1001 JOHN ST

SEATTLE WA, 98109
DPD# 3020563

WEST DESIGN REVIEW BOARD:
DESIGN RECOMMENDATION 2 MEETING
JULY 13, 2016

Recommendation Response Comments Matrix

Previous section details

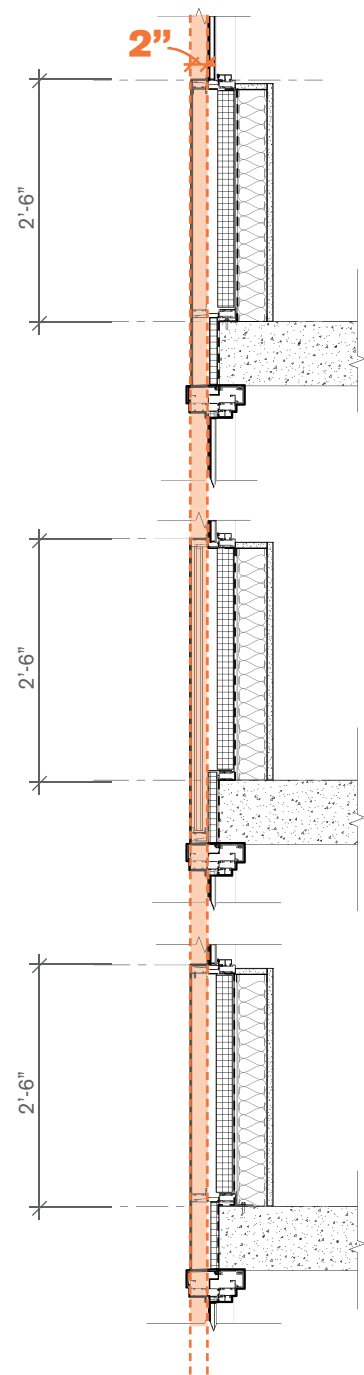
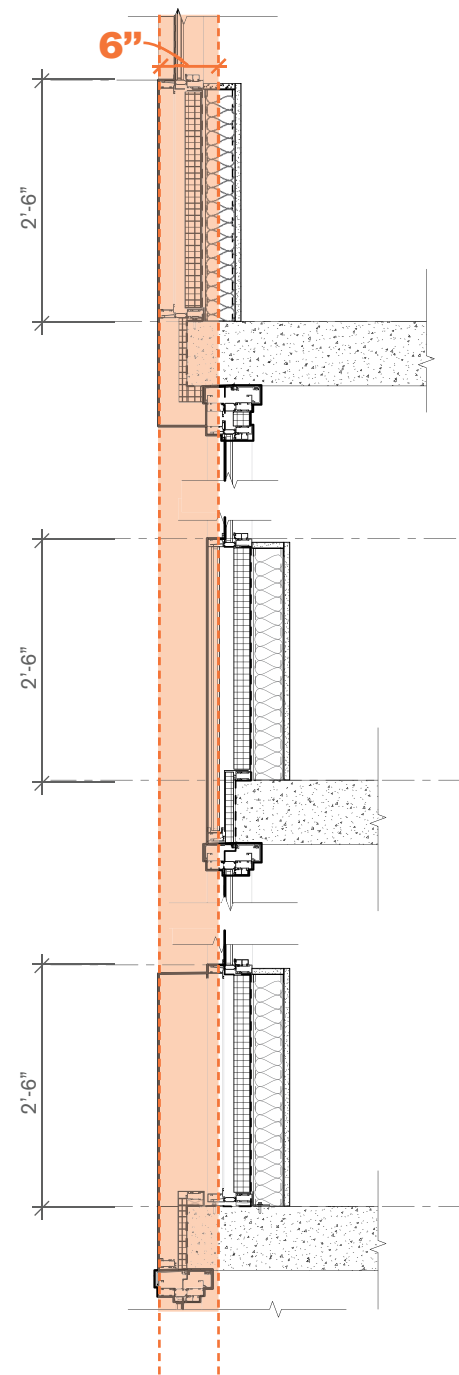
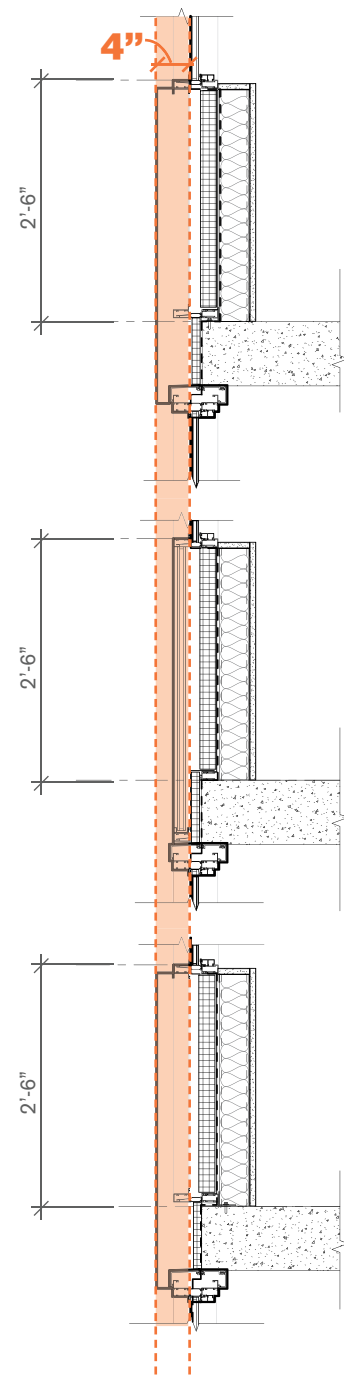
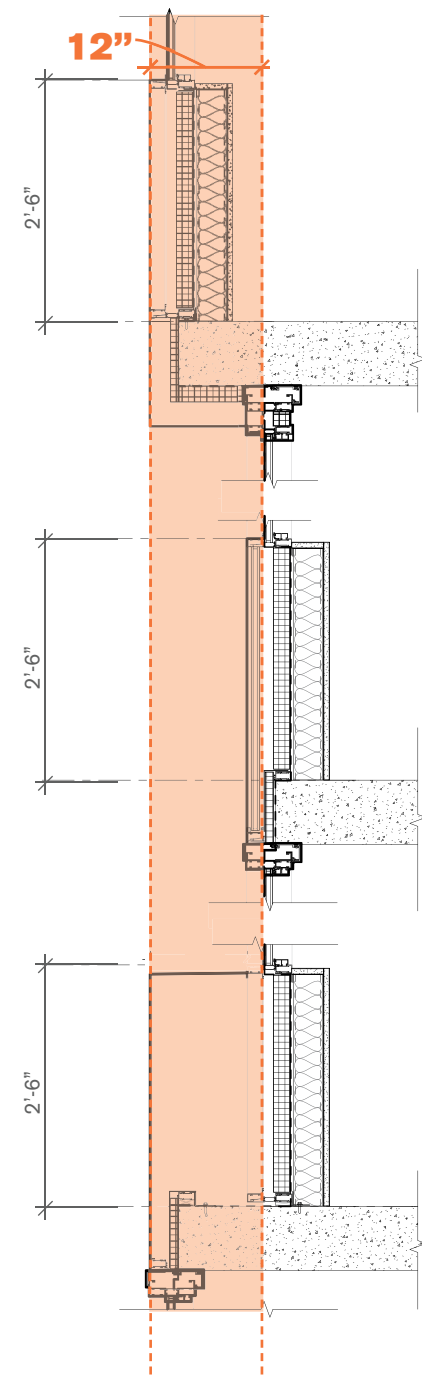
a. At the northeast corner and north façade, the Board agreed that the rhythm of four floors of glass and ‘white’ metal panels separated by two floor of vision and spandrel glass, should be emphasized by providing a 12” setback of the 2-story section so that it is clearly legible. (DC2.B.1)	At the previous DRB meeting the setback was 6” due to constructability and maintenance issues. The applicant will recess the 2- story section 12”. Along with the darker spandrel this will make the 2 story section visibly recess.

b. The Board was concern with the overall flatness of the tall and highly visible elevation and recommended that at the bronze metal facades, the vision and spandrel glass should be set back by 8” to create greater texture and depth to these elevations. (DC2.B.1)	The applicant had proposed a 2” recess between metal panel and face of glass in the typical window section. This amount of recess is more than the usual amount seen with many glass/metal panel buildings in the city. To meet the request of a deeper recess the applicant has worked with the window wall supplier, contractor and manufacturer to attain the maximum amount possible with the window-wall system which is 4”. The applicant is also using a darker window frame color to help add depth to the wall. The applicant will also be using a 2-coat “mica” metal finish to add further visual interest to the bronze panels.

NORTHEAST CORNER

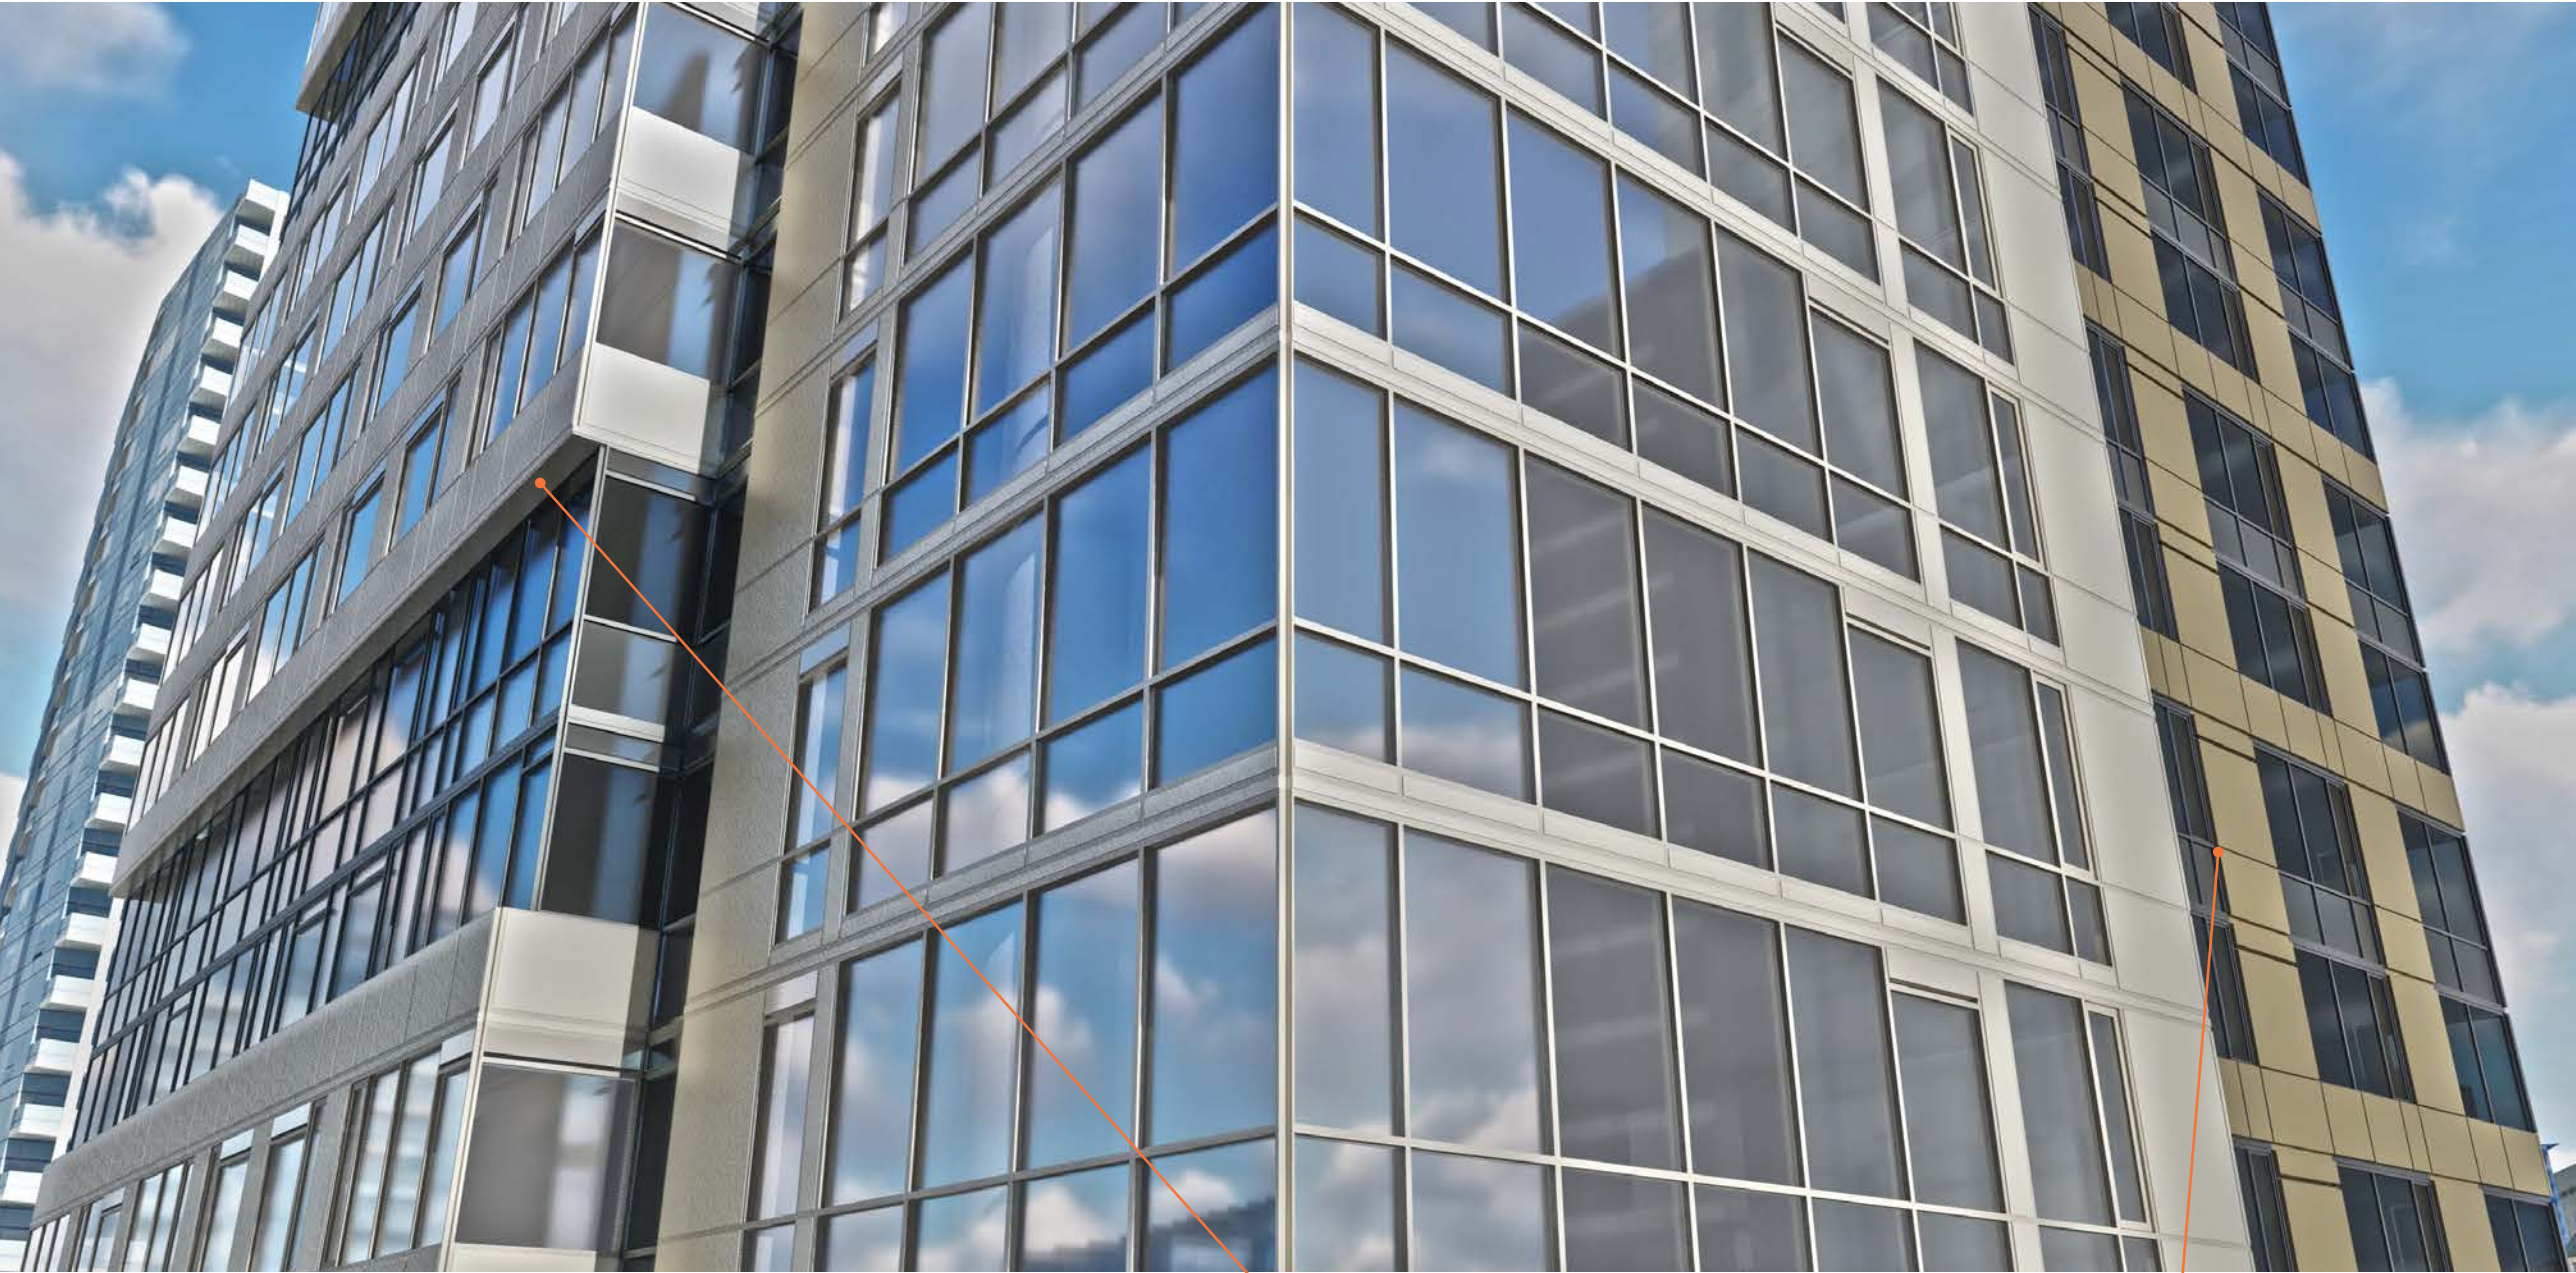
c. Maintain the 2’ fin shown on the east elevation. (DC2.B.1)	Fin expression maintained at 2'-0” depth and has been thickened from 12 “to 18” to further emphasize this element.

c 24" fin depth

b 4" skin depth (maximum system capability)

a 12" set-back

Rooftop Amenity

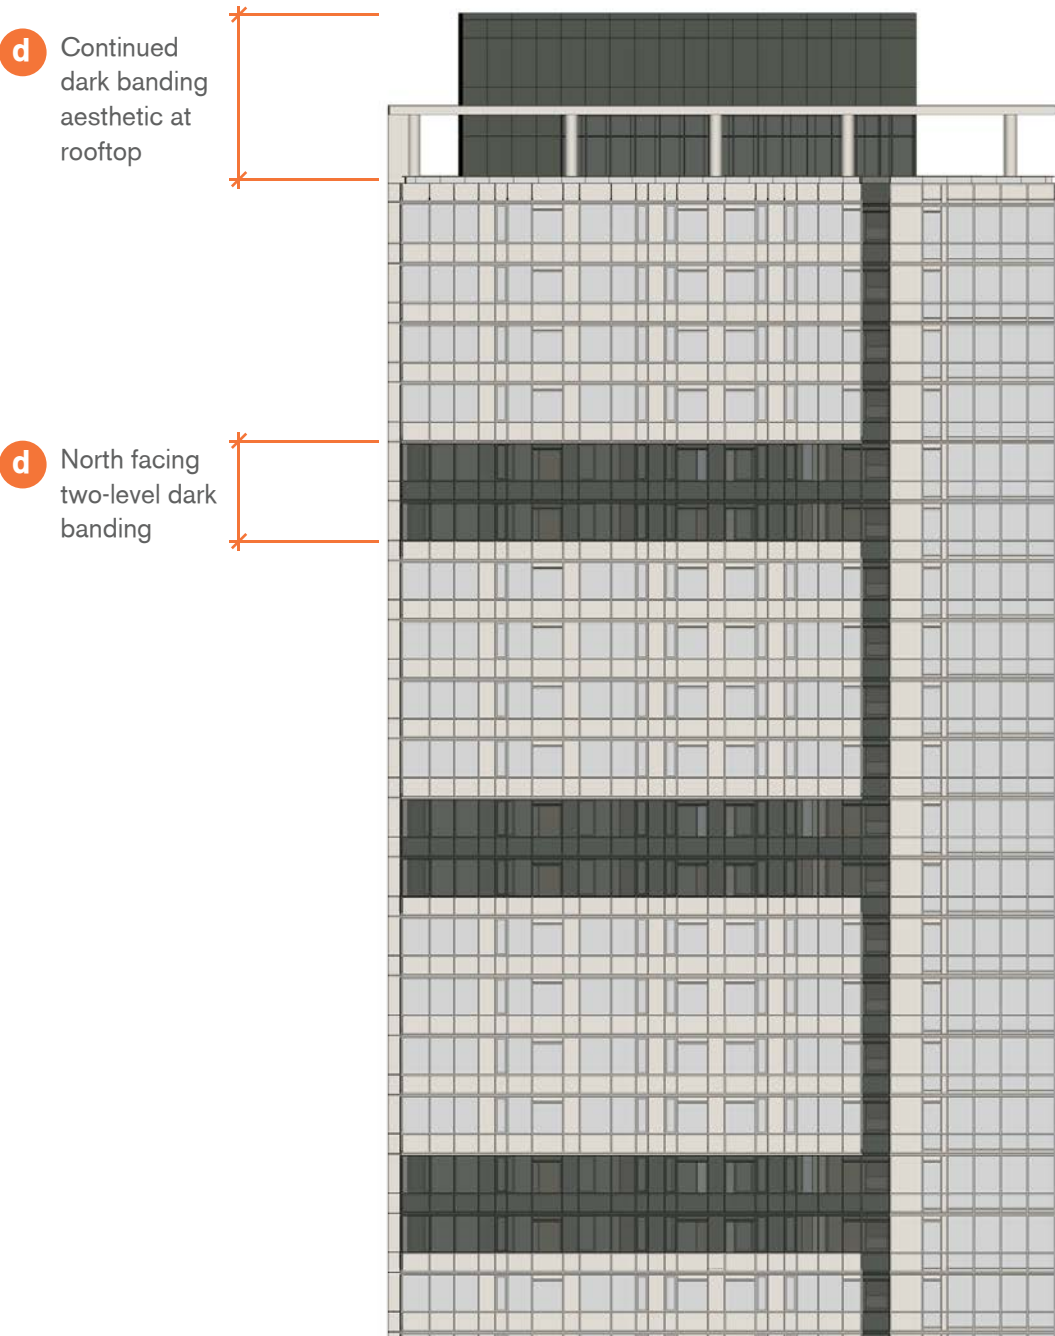
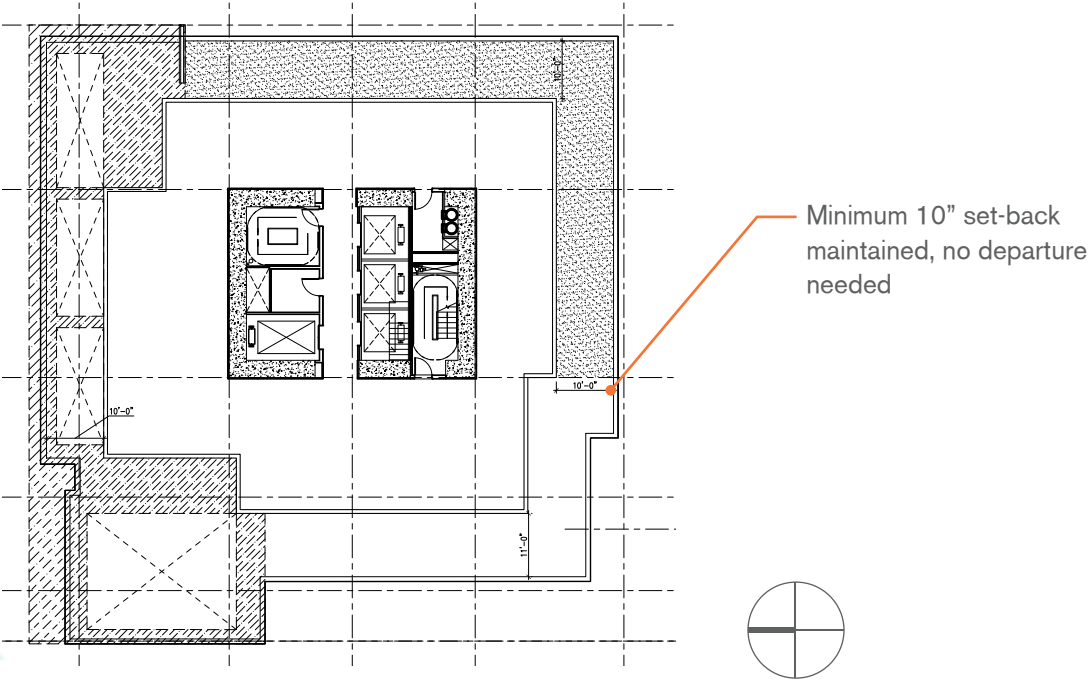
d. Design the top of the tower to create a graceful termination of the bronze metal panel facades, using different heights, visually pleasing proportions and a resolution of the amenity space windows. Vary the material colors at the recessed portions and consider a dark color that recedes. (DC2.B.1)	The top of the building has been redesigned and simplified as an elegant rooftop “pavilion”. To the north the white visor will frame the view to Lake Union and provide a strong visual termination to the tower and be an intermediately scaled feature to “lock-in” the darker roof massing. On the west side the amenity floor has been stepped back to create an outdoor terrace and eliminate the need for a departure. Three vertically proportioned 15’ bays and glass corner relate to the bay spacing of the tower body below. To the south the building top steps in plan to relate to the tower massing. The east façade continues the 15’ bays which, along with the darker panel requested by the board, modulate the roof.
